Project: ARW Offfice Building Addition

Addendum 1

Date: October 21, 2025

Sheet AS2.2 Main Floor Finishes Plan

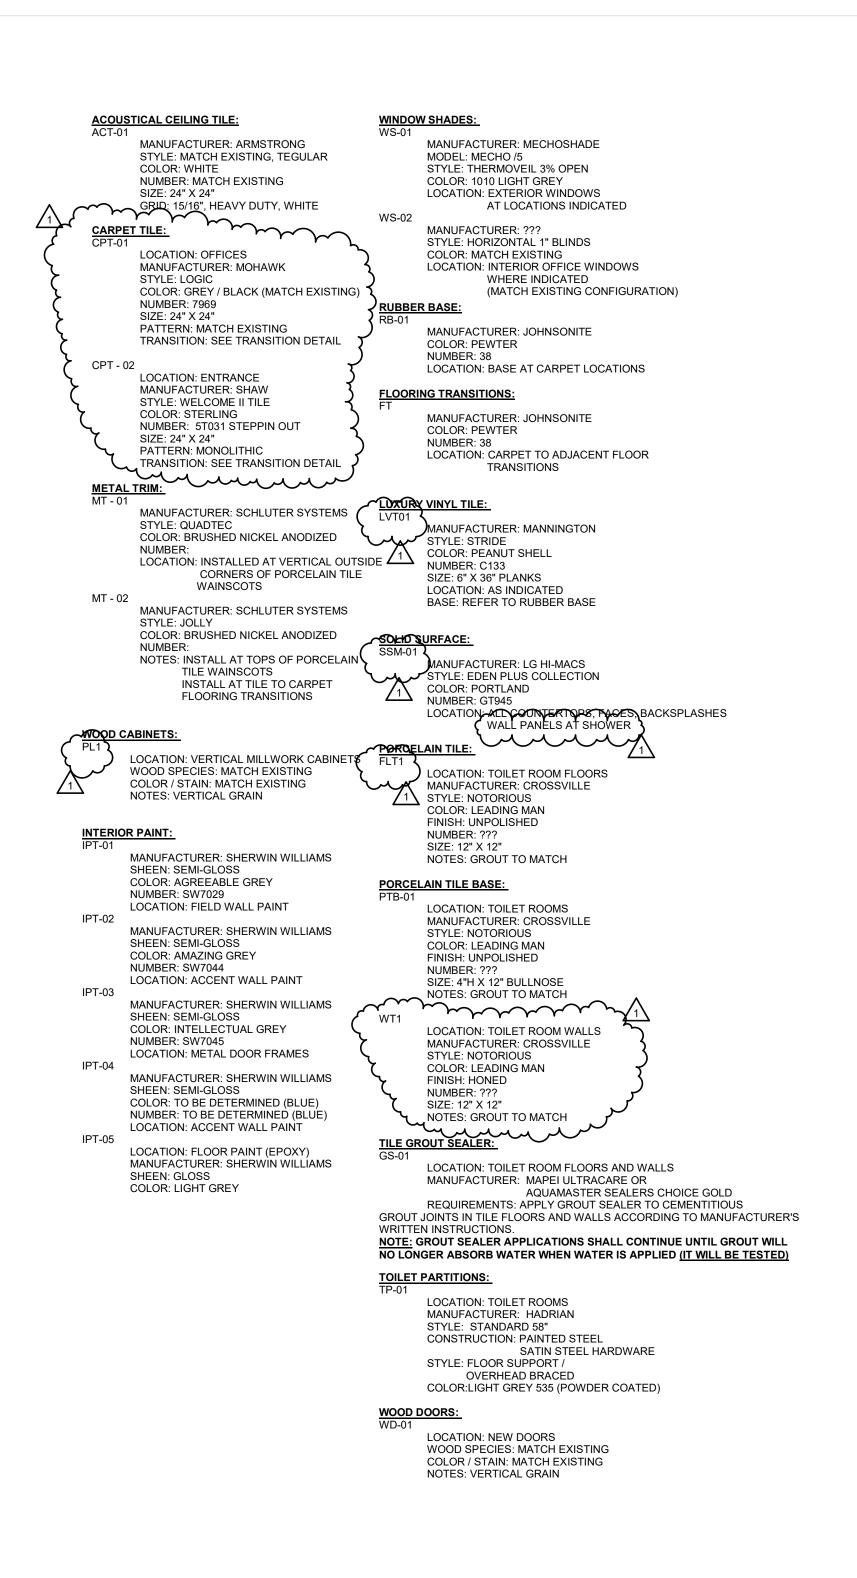
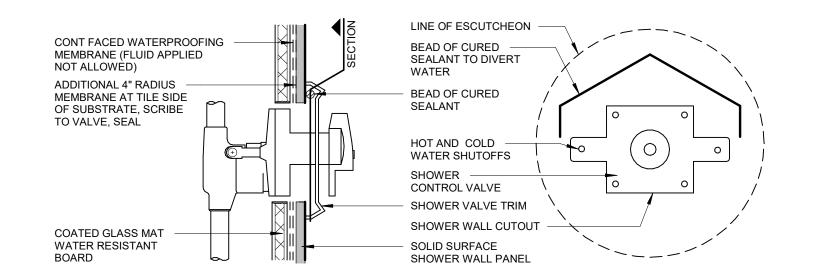
Add / Clarify: Material items have been clarified (designations) and added to

the finish plan

Sheet AS2.21 Finish Materials / Details

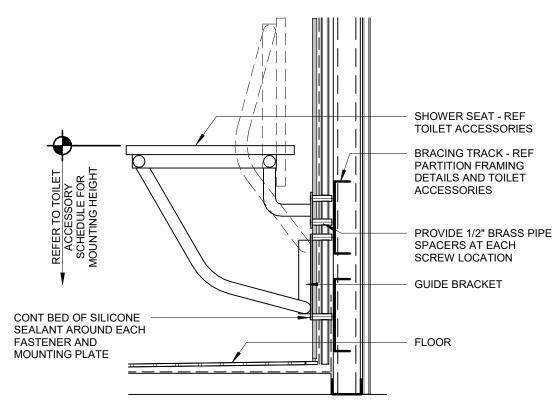
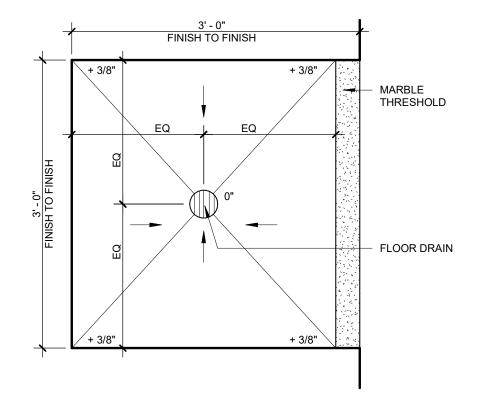
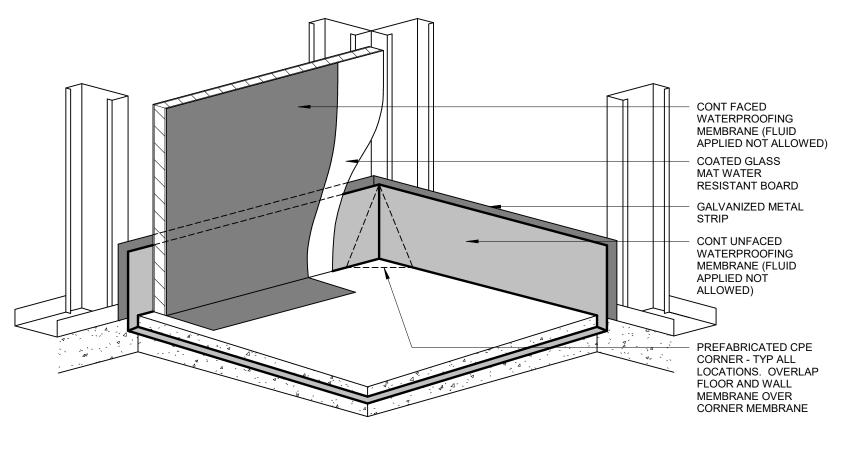
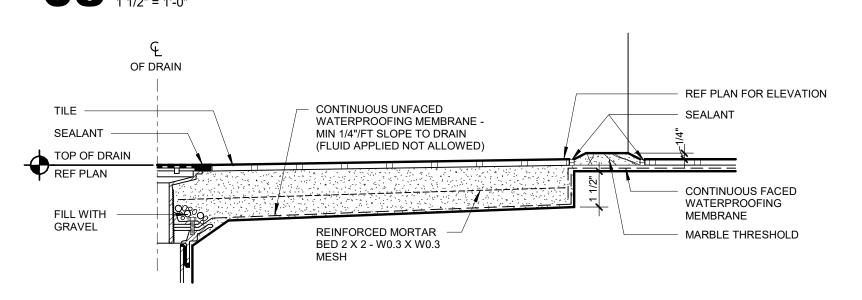
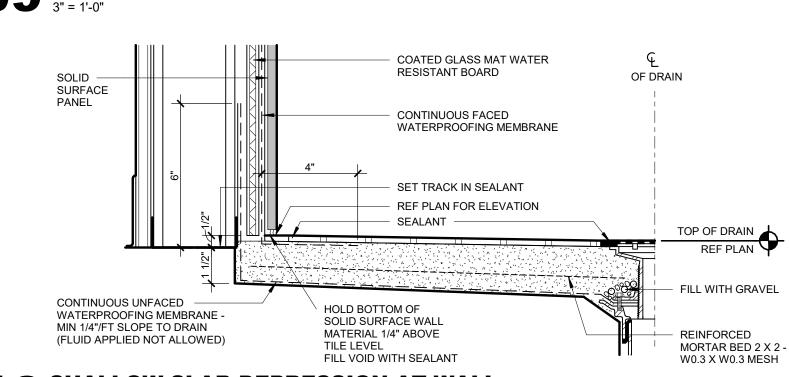
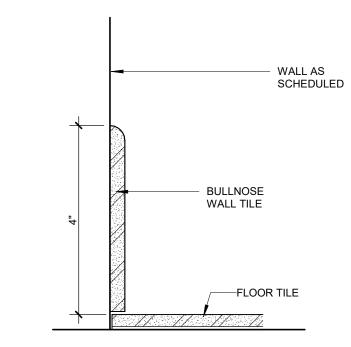
Add / Clarify: Material items have been clarified (designations) and added to

the finish materials list
